DOCUMENT TRANSMITTAL 2003-55196

TRM2 - TECHNICAL REQUIREMENTS MANUAL UNIT 2

# **Susquehanna SES Unit 2 Cycle 12**

## **CORE OPERATING LIMITS REPORT**

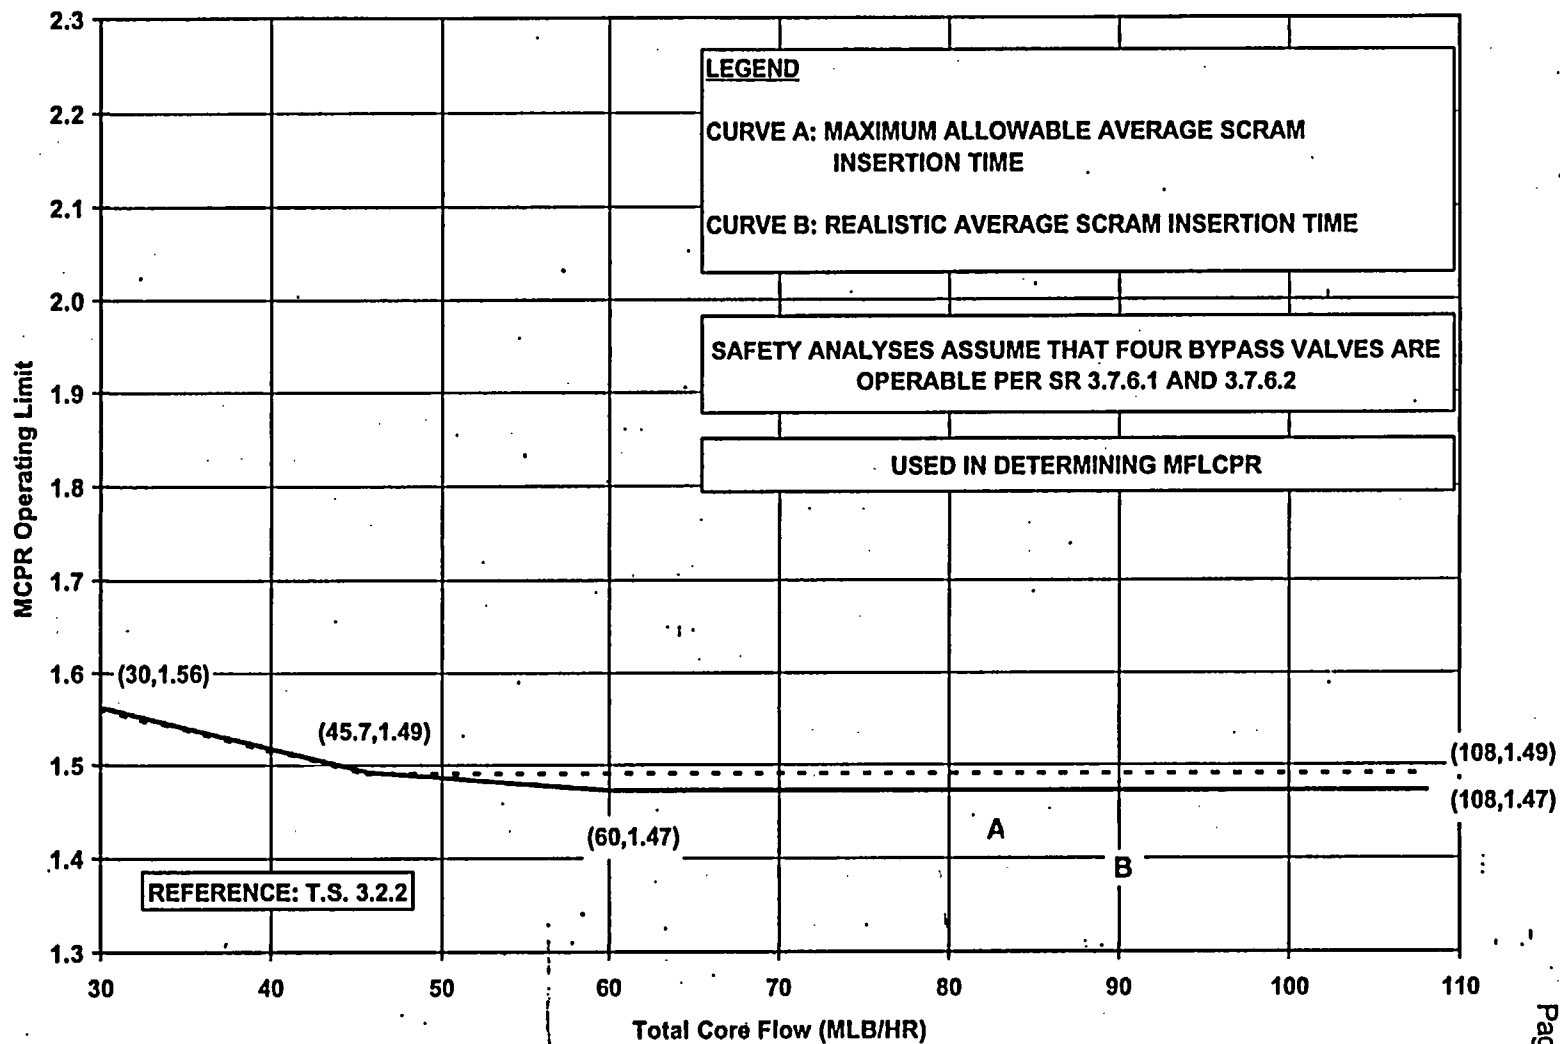
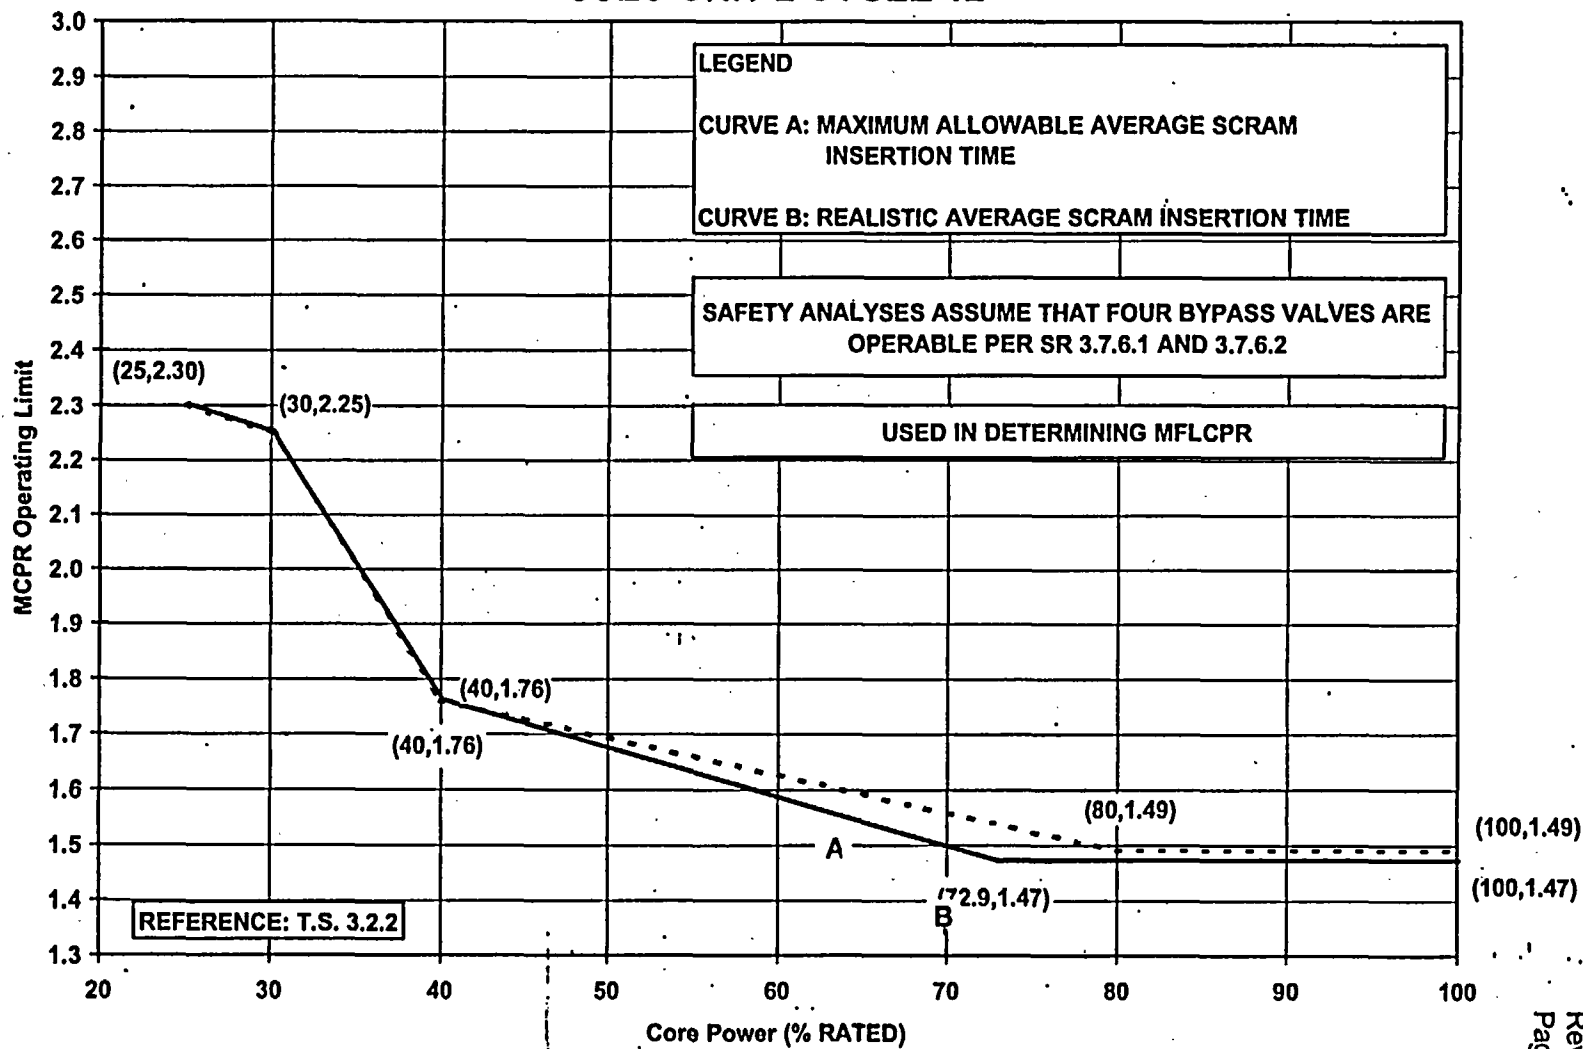
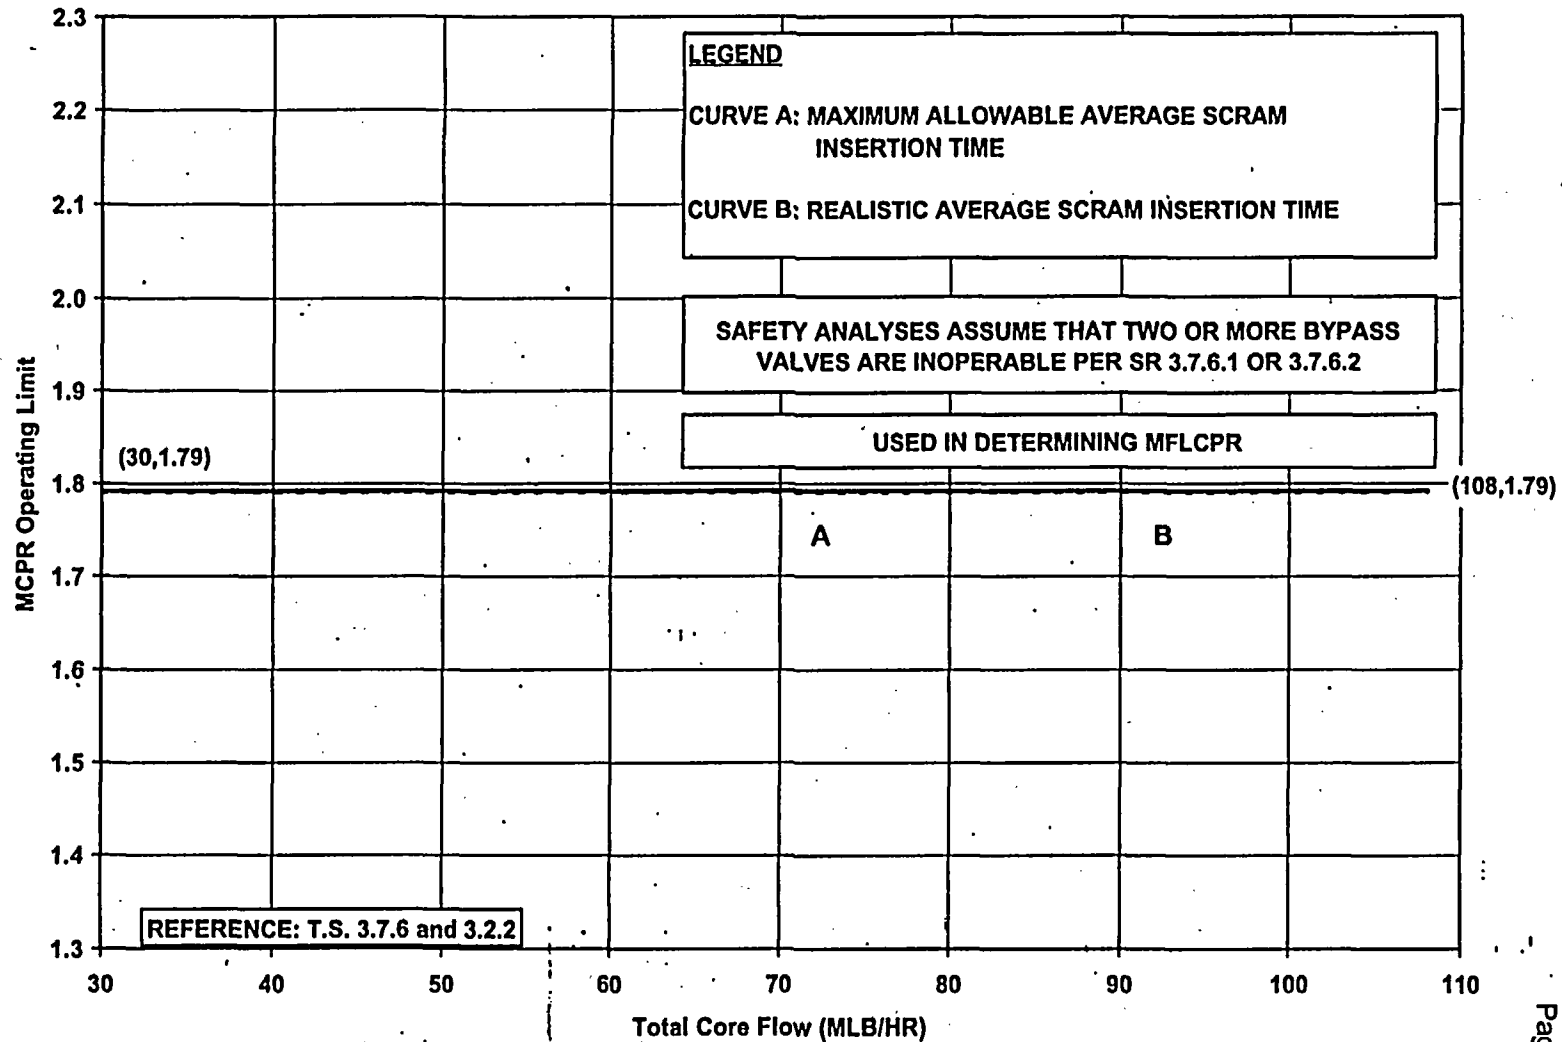
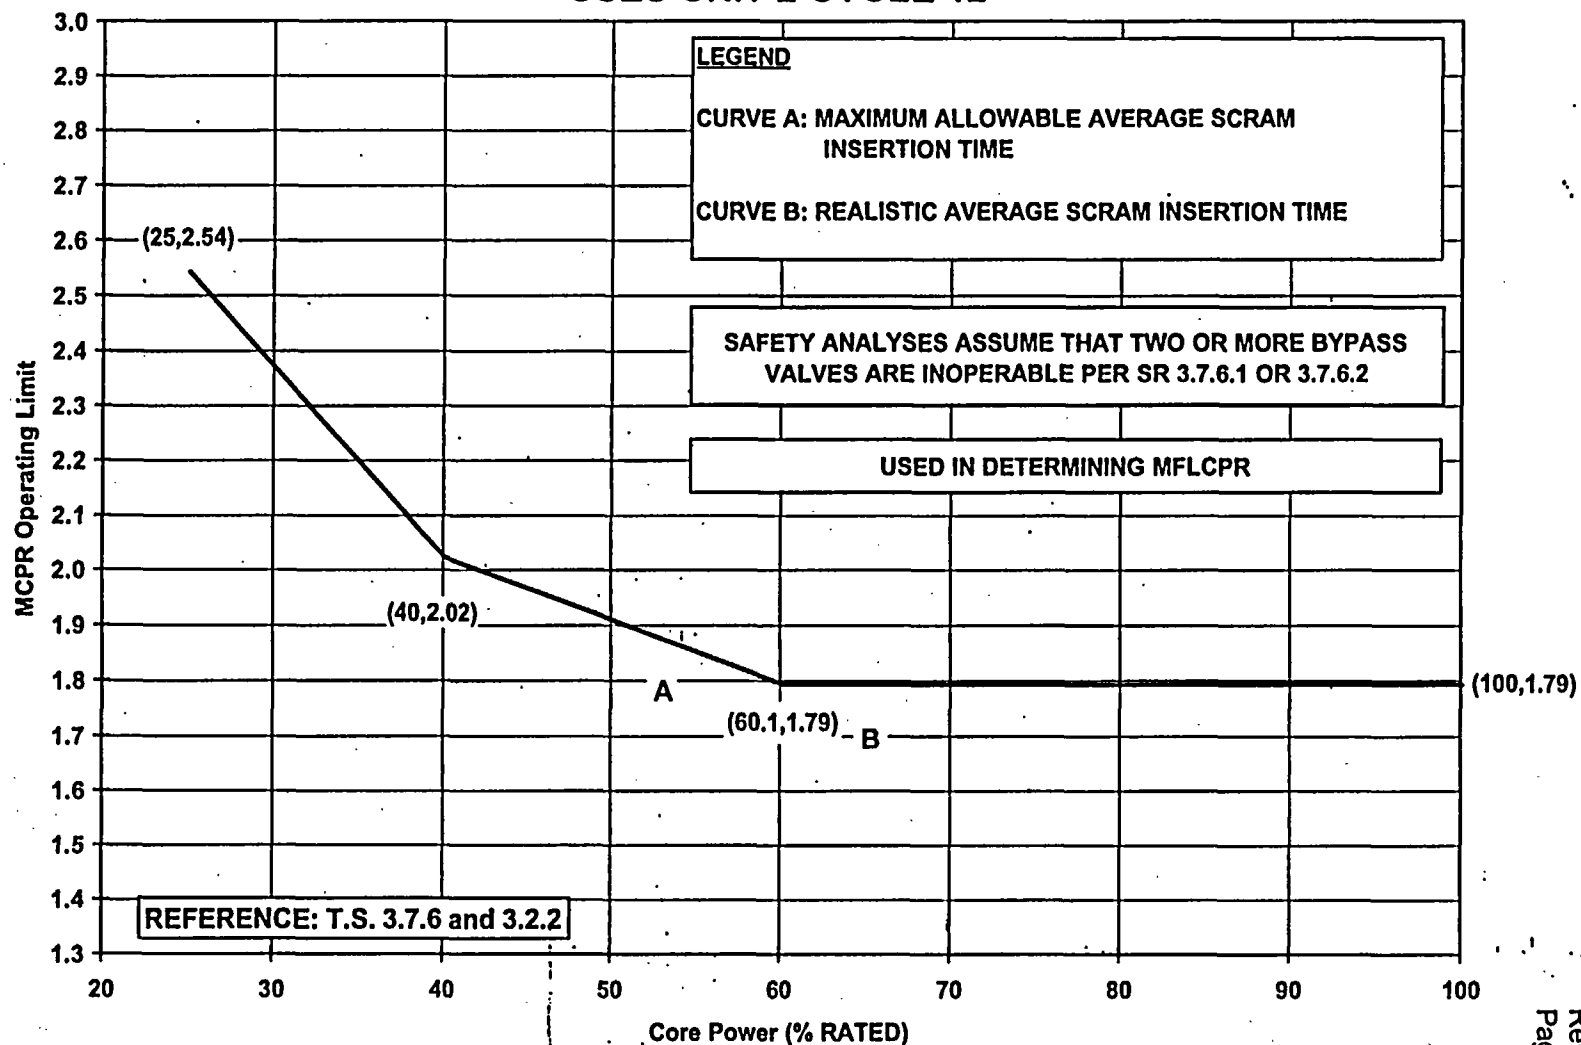
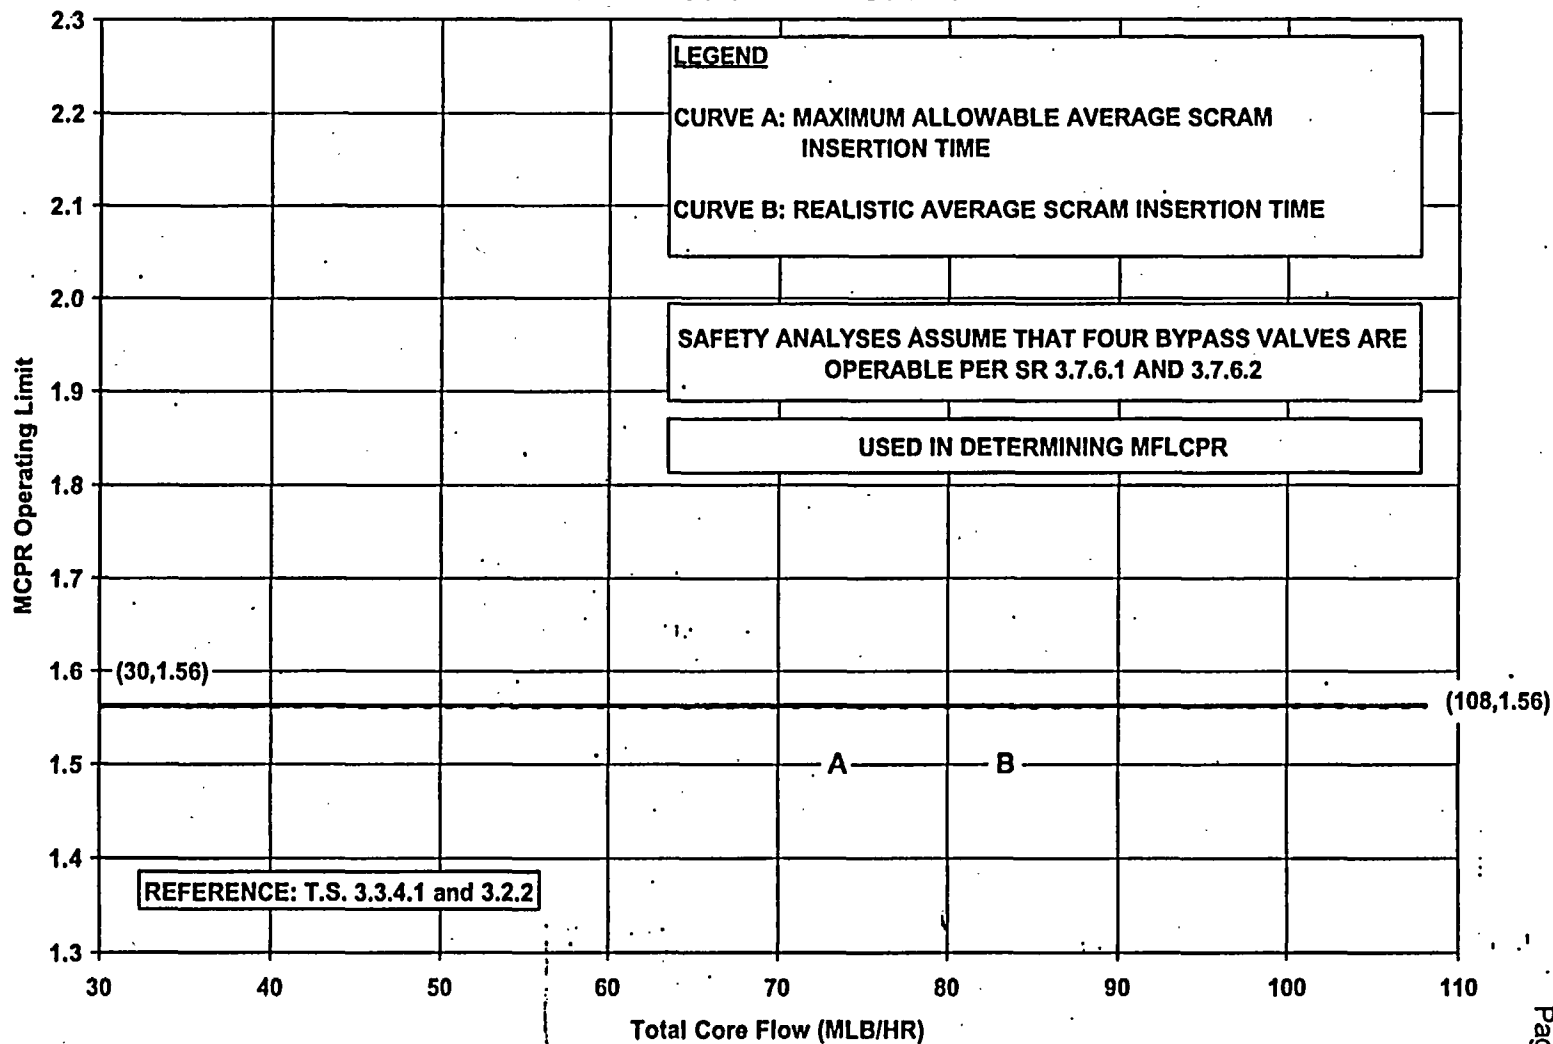
Rev. No.	Affected Sections	Description/Purpose of Revision
0	ALL	Issuance of this COLR is in support of Unit 2 Cycle 12 operation.
1	5.0 6.0 8.0	<p>This revision adds a text box to all appropriate plots. This text box indicates that for all bypass operable cases, four bypass valves are assumed operable. For the bypass inoperable cases, the text box indicates that two or more bypass valves are assumed inoperable.</p> <p>This revision was generated in response to Facility Operating License Amendment 185 which altered SR 3.7.6.1.</p> <p>This revision is administrative in nature and no underlying calculations or plotted data were altered.</p>
2	TOC 1.0 9.0 10.0	<p>This revision adds the Power / Flow map to the COLR. Section 1.0 was revised to include the stability regions as part of the COLR. The Power / Flow map was added as Section 9.0. The Reference section was renumbered as Section 10.0 and a stability reference added.</p> <p>This revision is administrative in nature since the Power / Flow map is already included in NDAP-QA-0338.</p>
